Source: TSG SA WG2
Title: CRs on 23.121 v 3.1.0
Agenda Item: 5.2.3

The following CRs have been approved by TSG SA WG2 and are requested to be approved by TSG SA plenary #6.

TDoc #	CR #	spec	Title	cat
S2-99B81	042r1	23.121	Gateway Location Register	C
S2-99B58	043r1	23.121	Clarification of SMS sending in UMTS	F
S2-99B63	044r1	23.121	SRNS Relocation for PS domain for the case of RT	C
S2-99E63	045r1	23.121	Cell Broadcast System Architecture	B
S2-99B61	046r1	23.121	Additional modifications related to UMTS area concept change	C
S2-99C02	047	23.121	Correction of criteria for data volume reporting from RNC to SGSN	F
S2-99D31	051	23.121	Mobile IP	B
S2-99E06	052	23.121	Termination point of the GTP-U tunnel	F

Figure 53 : Protocol architecture for 3G SMS for both a CS service domain and a PS service domain

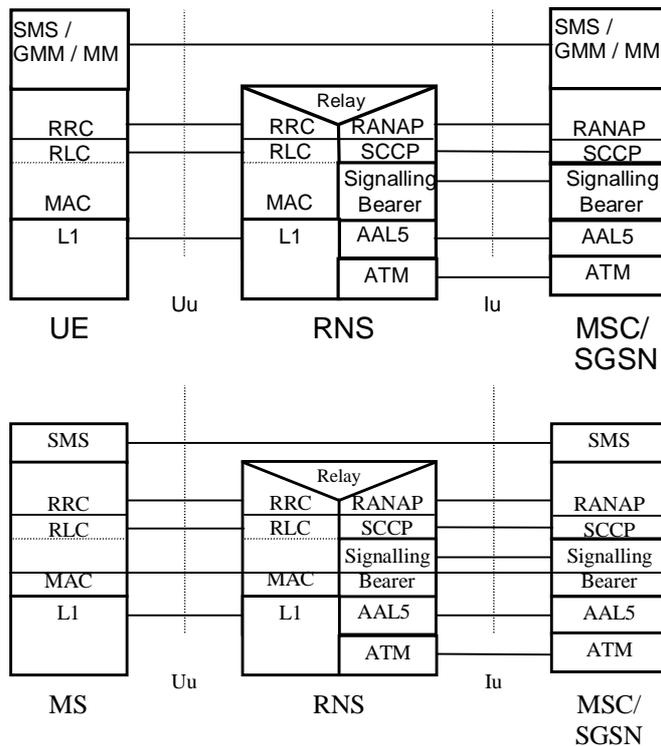
Currently 23.121 defines, that SMS sub-layer uses services of the RRC directly to send SMS on C-plane. However, for the CS-domain SMS uses service of the MM similarly than already defined in GSM. Also, for the PS-domain similar service request procedure has been approved for GMM in order to establish a secure connection between UE and 3G-SGSN. This CR proposes to clarify the issue in 23.121 and to remove any possibilities for inconsistency between different specifications.

When assuming that there is no LLC for the PS Domain Layer2 protocol, The LLC layer is only applicable for GPRS and not for UMTS. Due to that there is a need to reconsider the functionality which had been done at LLC in GPRS. There are two alternative described below.

The C-plane is a signalling connection between UE and MSC or SGSN, respectively. Establishment of a secure signalling connection is offered by the GMM in the PS domain and by the MM in the CS domain. SMS is a user of that secure signalling connection.

Figure 4 42: Protocol Stack of the Common Communication Channel

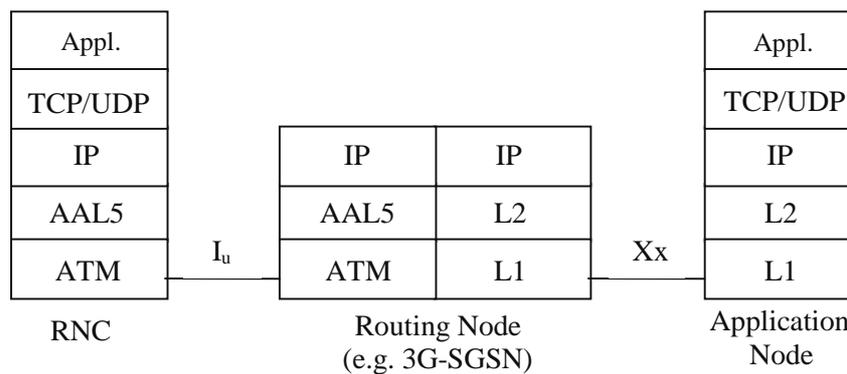
Reason for change: The responsibilities for the cell broadcast specification are clarified now and work has started in RAN and T. RAN3 has considered the CBC-RNC protocol as part of Release 99. Therefore the Cell Broadcast Architecture described in the 23.920 should be moved to 23.121 with additional clarification. This CR covers the needed changes. ~~In addition some editorial changes are proposed:~~

- Clarification of the role of the BC reference point and the relation between the RNC and the CBC
- Deletion of the section on the common communication channel
- Option for second CBC for LCS

~~3. Addressing of the Application and Application node by the RNC(s).~~

~~4. Addressing (dynamic or static) of the application (e.g. CBC) on the RNC(s).~~

Figure 4-28: Data paths before the SRNS relocation has been actually committed (before point (a) in Figure 4-27)

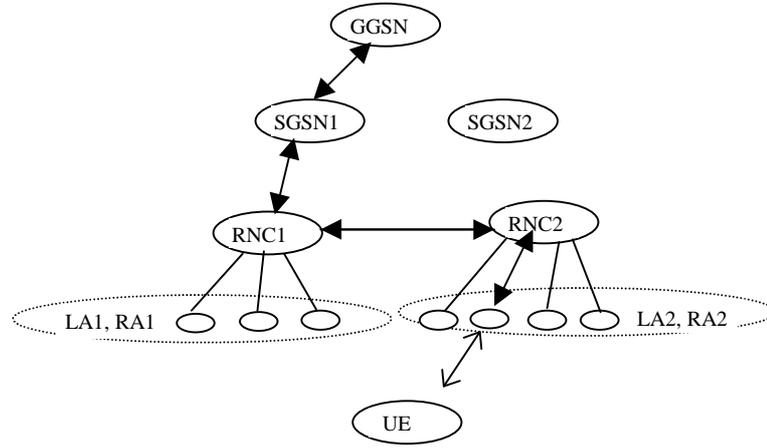
Reason for change: Current TS 23.121 describes mainly SRNS Relocation procedure in case of PS domain non real time data service with high reliability. The case of Real Time services needs also to be described.

Before point (a), in Figure 4-27, the connection is established between UE and GGSN via Source SRNC and SGSN1.

Figure 25: Periodic update procedure when the MS is attached for both CS and PS services

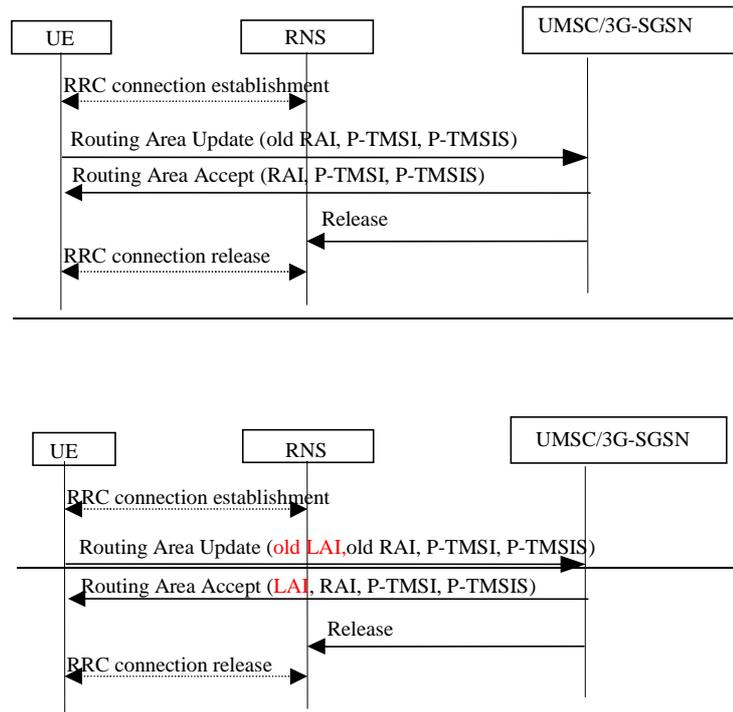
Reason for change: In Bonn meeting, it was agreed that the area concept for UMTS should be as same as GPRS R97. In 4.3.12.1.4, 4.3.13.6, 4.3.13.7 there are also descriptions which still obey old concept according to CRA16(S2-99530). This CR proposes the deletion of those descriptions.

An RRC connection is established for the periodic registration. Note that this procedure is invoked only when the UE is in MM-idle state. The UE sends a Routing Area Update to the UMSC. The UMSC authenticates the P-TMSI signature. If the update is successful it sends a Routing Area Accept message. The RRC connection is then released.

Figure 4-47. PDP Context activation with Mobile IP registration (the PPP set-up and UMTS/GPRS attach procedures not included)

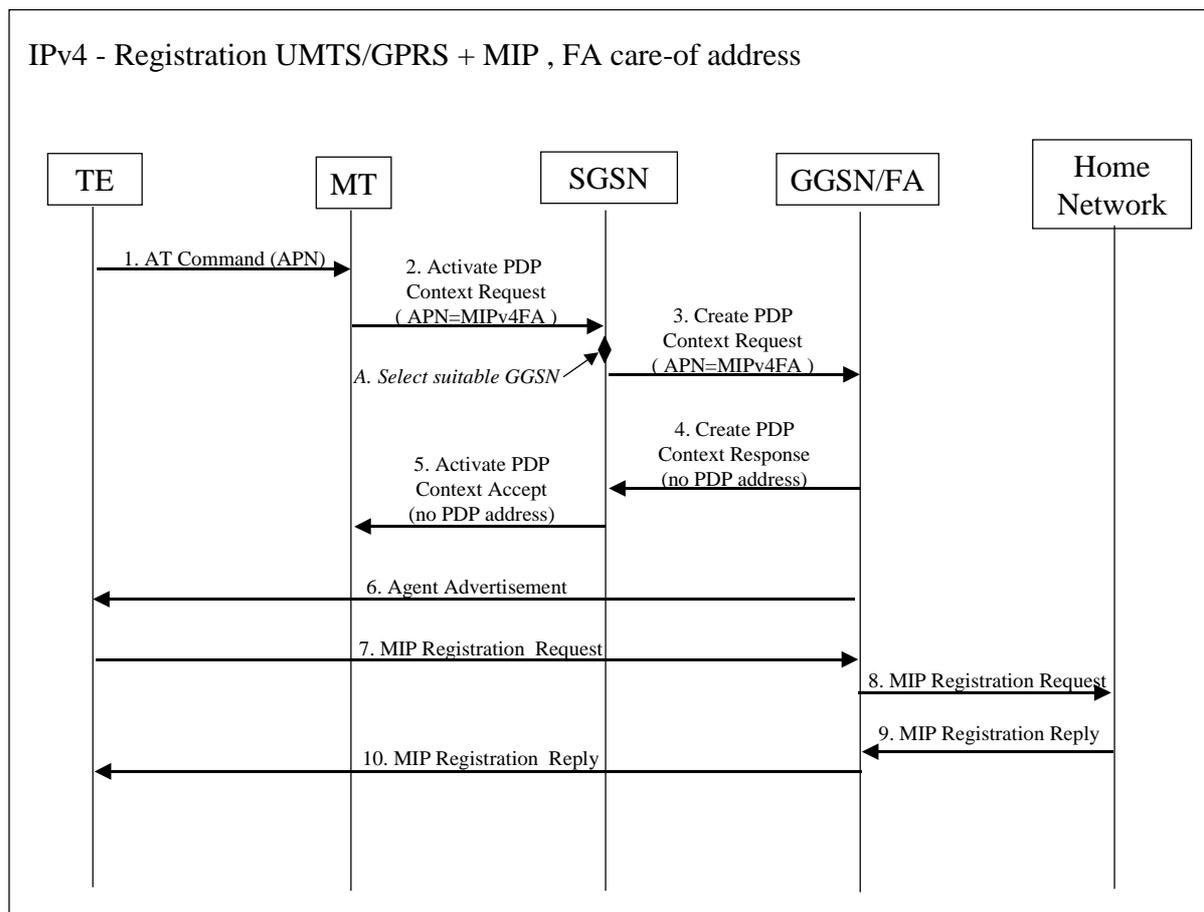
2. The MT sends the “Activate PDP Context Request” to the SGSN. The message includes various parameters of which the “APN” (Access Point Name) and the “Requested PDP Address” are of interest here. ~~The APN, which is discussed in detail below, points at a requested GGSN.~~ The MS may use APN to select a reference point to a certain external network and/or to select a service. APN is a logical name referring to the external packet data network and/or to a service that the subscriber wishes to connect to. The “Requested PDP Address” should be omitted for all MS’s using Mobile IP. This is done irrespective of if the MT has a permanently assigned Mobile IP address from its Mobile IP home network, a previously assigned dynamic home address from its Mobile IP home network or if it wishes the Mobile IP home network to allocate a “new” dynamic home address.

4. A Create PDP Context Response is sent from the GGSN/FA to the SGSN. If the creation of PDP Context was successful, some parameters will be returned to the SGSN, if not, error code will be returned. ~~For Mobile IP users, the PDP address should be omitted.~~ If the GGSN has been configured by the operator to use a Foreign Agent for the requested APN, the PDP address returned by the GGSN shall be set to 0.0.0.0, indicating that the PDP address shall be negotiated by the MS with a Home Agent after the PDP context activation procedure.

A. The SGSN will base the choice of GGSN ~~is based~~ on the APN that is given by the MS.

5. The Activate PDP Context Accept message is sent by the SGSN to the MS and contains similar information as the Create PDP Context Response message. ~~The PDP address should be omitted.~~

10. ~~The FA~~ and forwards the message to the mobile node in the UMTS/GPRS user plane. As the FA/GGSN knows the TID and the NAI or home address, it can pass it on to the correct MS. A home address of the MS allocated by the home network is sent to the SGSN by means of the "GGSN-Initiated PDP Context modification procedure" described in [23.060]
